ADDENDUM NO. 5

**BREWSTER CENTRAL SCHOOL DISTRICT
BREWSTER HIGH SCHOOL
SECURITY VESTIBULE, SYNTHETIC FIELD AND RELATED WORK**

DATE: May 9, 2024

This Addendum consists of two (2) pages plus Sketch SK-13, SK-14 and drawings BHS LS-100 and BHS LF-100.

DRAWING TITLE:
PARTIAL ROOF PLAN
{REF: 1&2/BHS-A113}

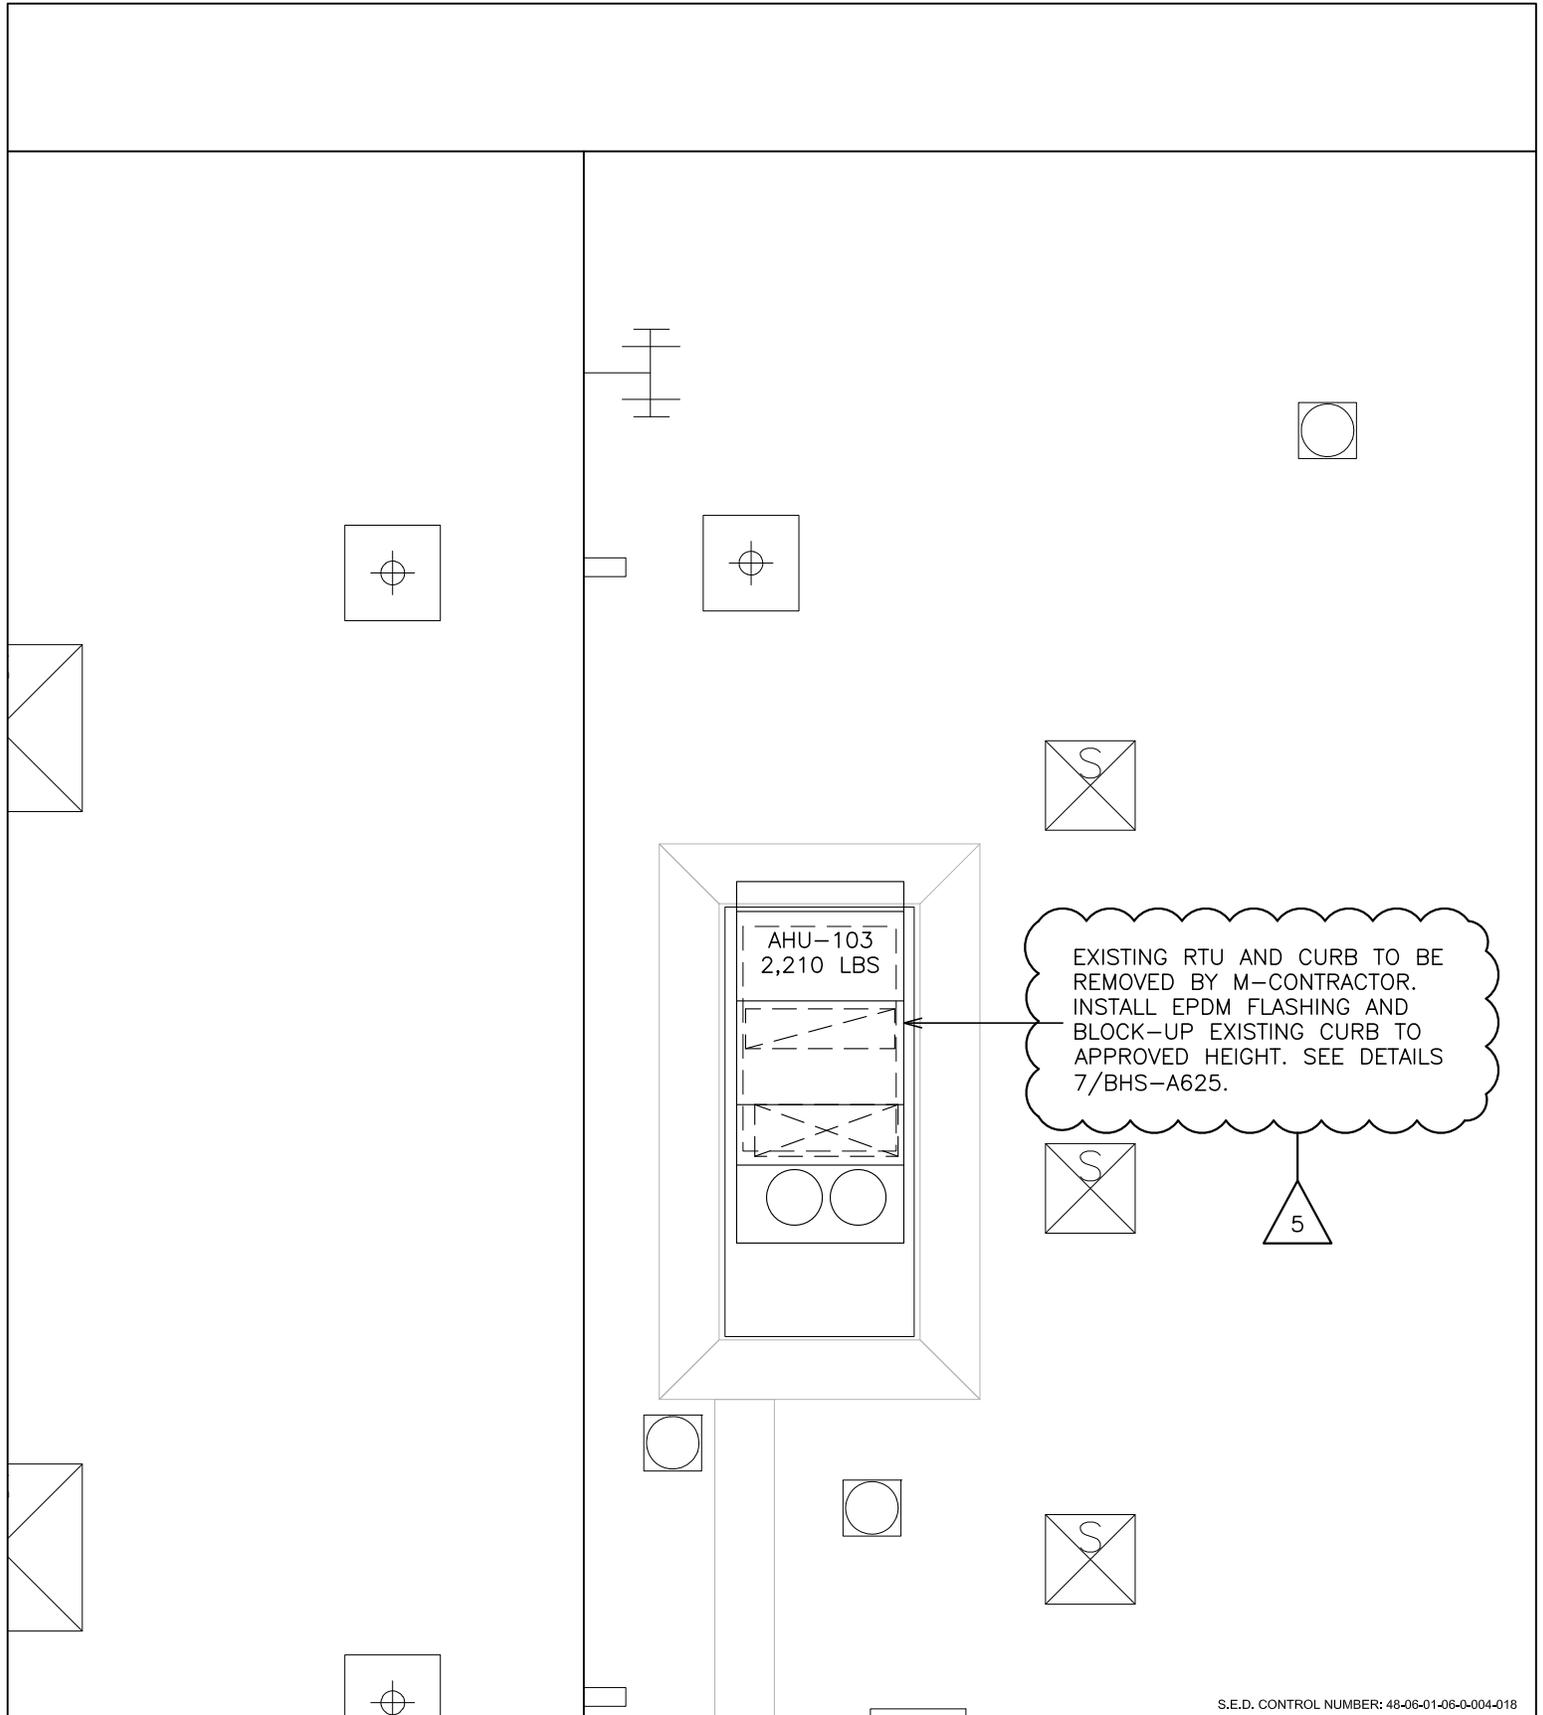
BHS A113 – ROOF PLAN

ADD Note as indicated on Sketch SK-13 attached to this addendum.

- 1. See addendum #5, SK-13.**
- 2. Flashing tar.**
- 3. Roof Area D gets a Liquid Applied roof.**

DRAWING TITLE:
MECHANICAL CURB DETAIL
{REF: BHS-A625}

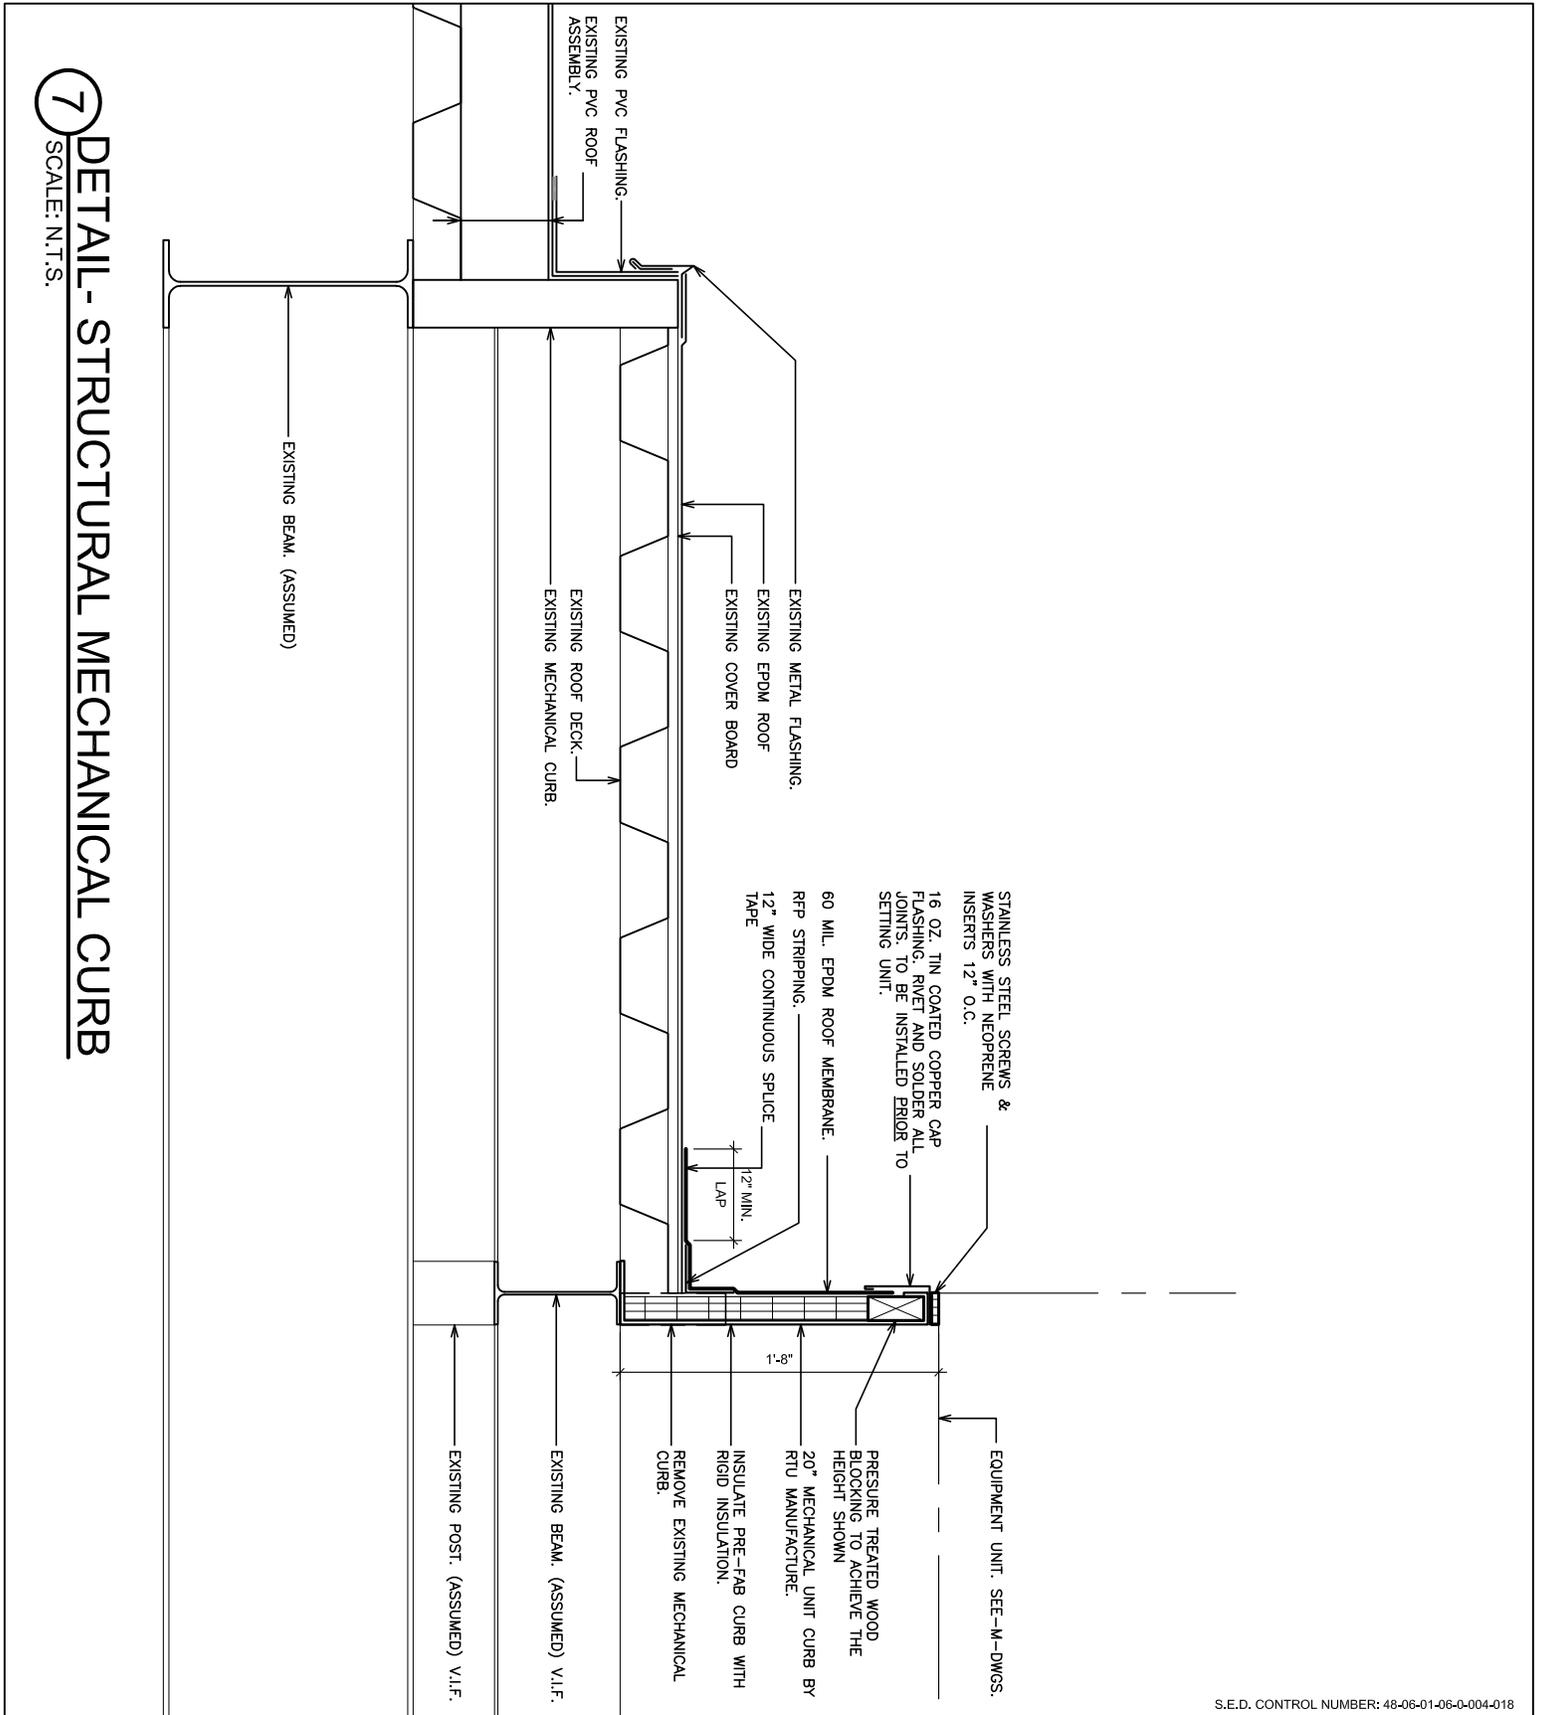
BHS A625 – ROOF DETAILS

ADD Detail 7 as indicated on Sketch SK-14 attached to this addendum.

7 **DETAIL - STRUCTURAL MECHANICAL CURB**
SCALE: N.T.S.

DATE	ISSUED TO
SHEET SIZE 30"x42"	DRAWING NO. BHS LS-100
SCALE	FILE NO. 23505.01
DRAWN BY JH

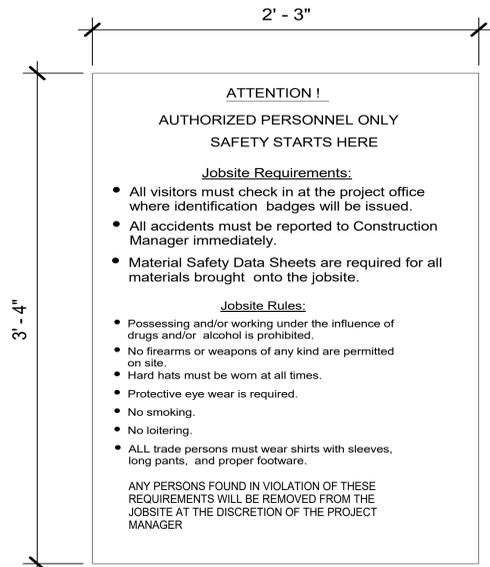
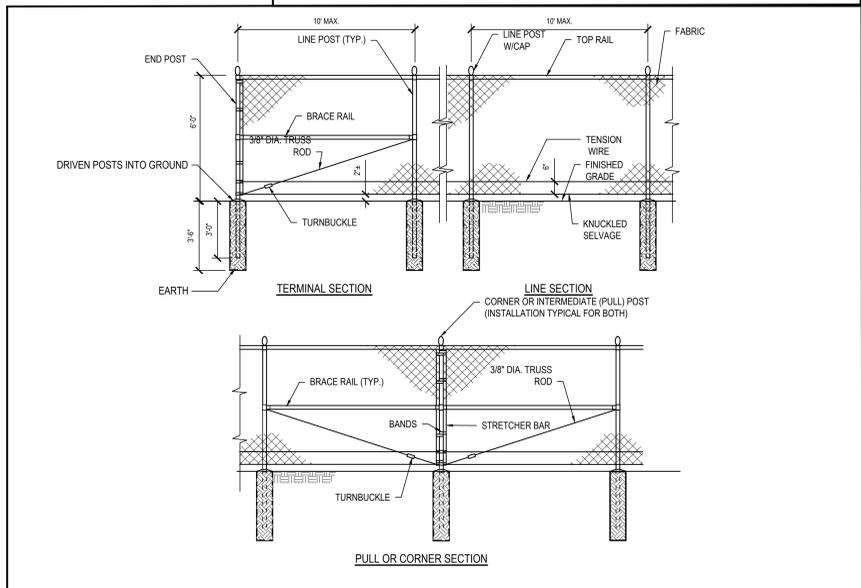
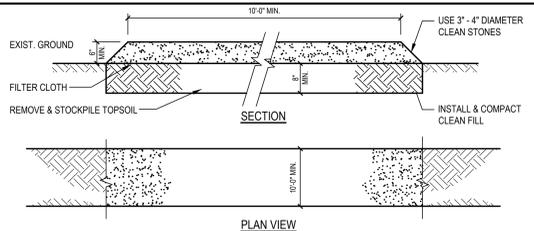
BHS LS-100 – STAGING & LOGISTICS

ADD drawing attached to this addendum.

PROJECT: BREWSTER CENTRAL SCHOOL DISTRICT BREWSTER HIGH SCHOOL SECURITY VESTIBULE, SYNTHETIC FIELD & RELATED WORK 50 FOGG/TOWN ROAD BREWSTER, NY 10899	DRAWING TITLE: STAGING & LOGISTICS
DATE:	ISSUED TO:
SHEET SIZE: 30"x42"	DRAWING NO.:
SCALE:	BHS LF- 100
DRAWN BY: JH	FILE NO.:
	23505.01

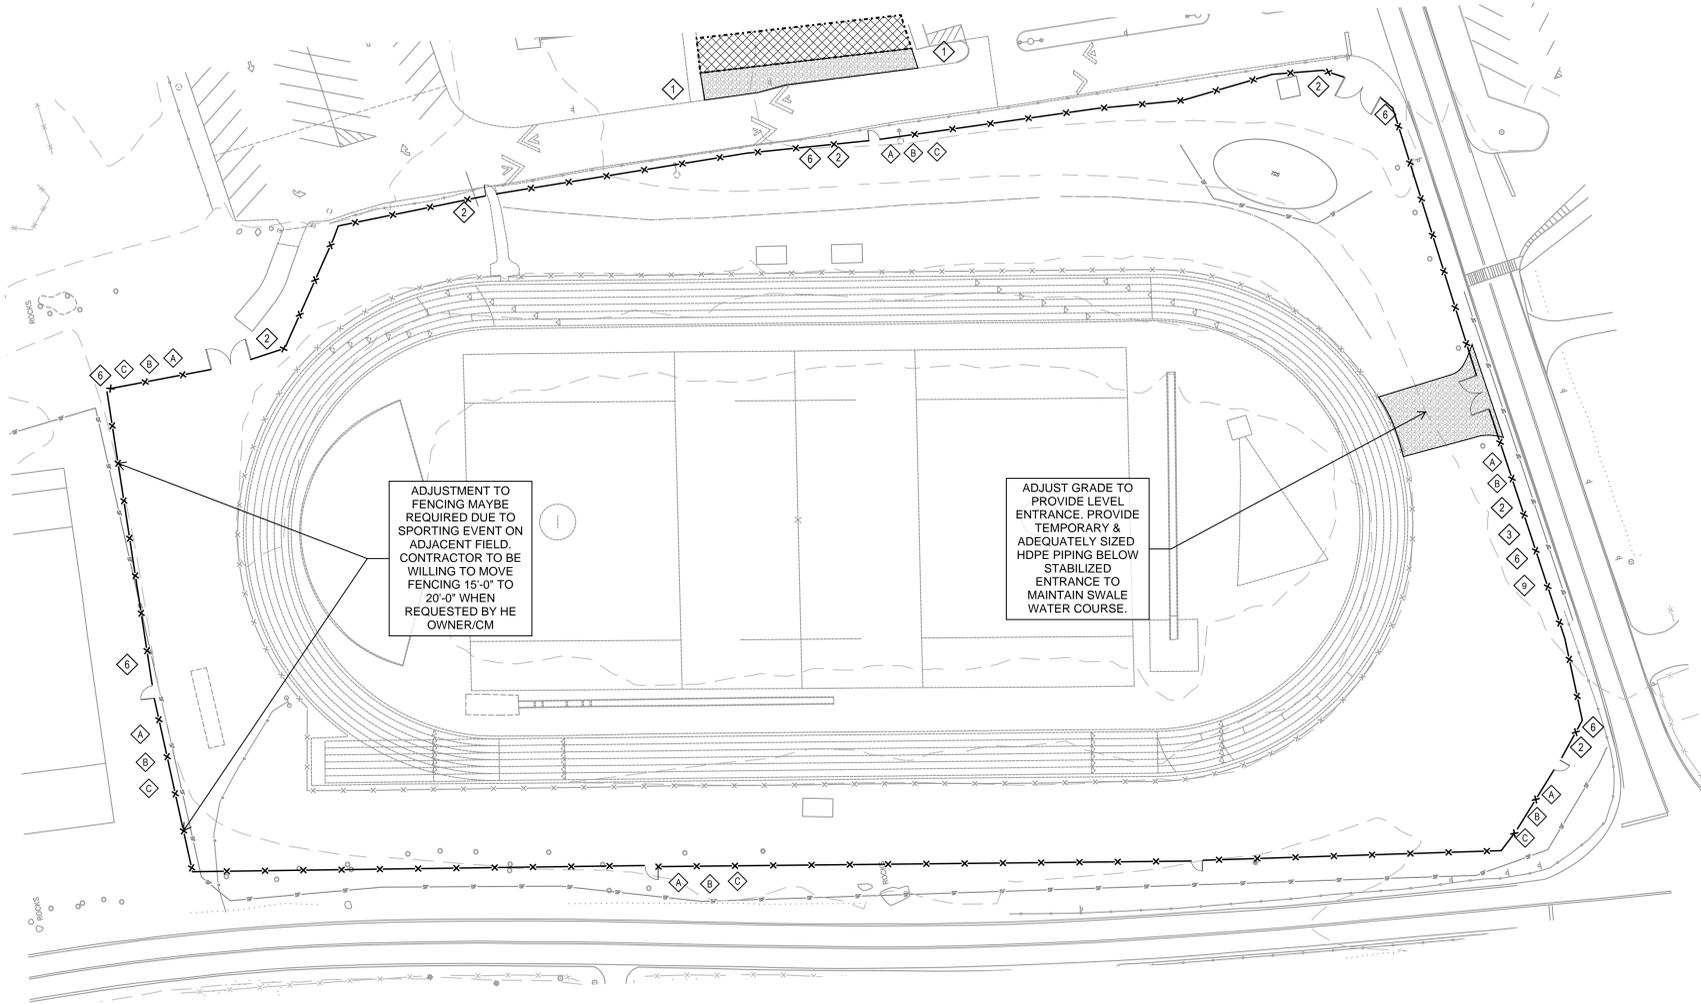
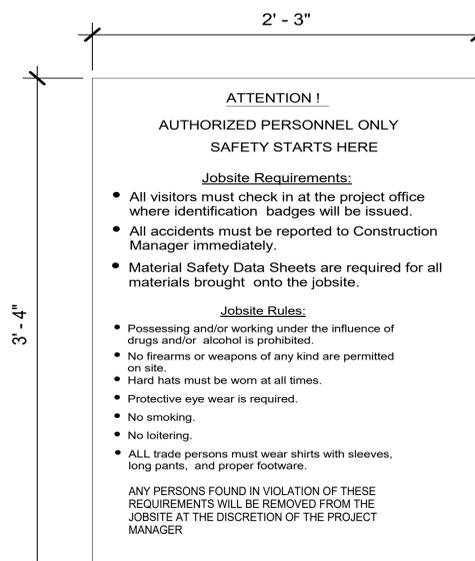
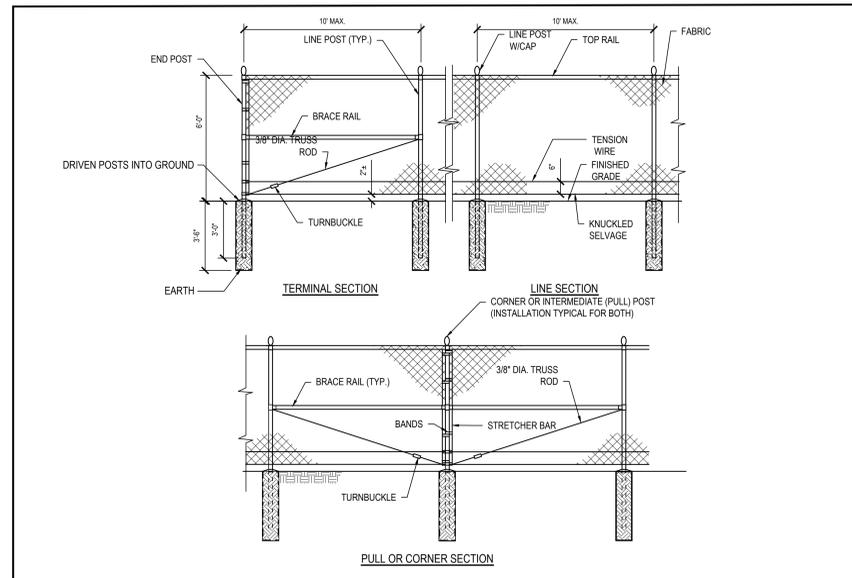
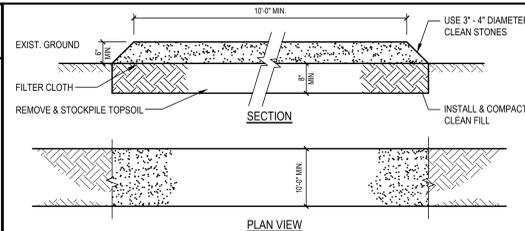
BHS LF-100 – STAGING & LOGISTICS

ADD drawing attached to this addendum.

ADJUSTMENT TO FENCING MAYBE REQUIRED DUE TO SPORTING EVENT ON ADJACENT FIELD. CONTRACTOR TO BE WILLING TO MOVE FENCING 15'-0" TO 20'-0" WHEN REQUESTED BY THE OWNER/CM

ADJUST GRADE TO PROVIDE LEVEL ENTRANCE. PROVIDE TEMPORARY & ADEQUATELY SIZED HDPE PIPING BELOW STABILIZED ENTRANCE TO MAINTAIN SWALE WATER COURSE.
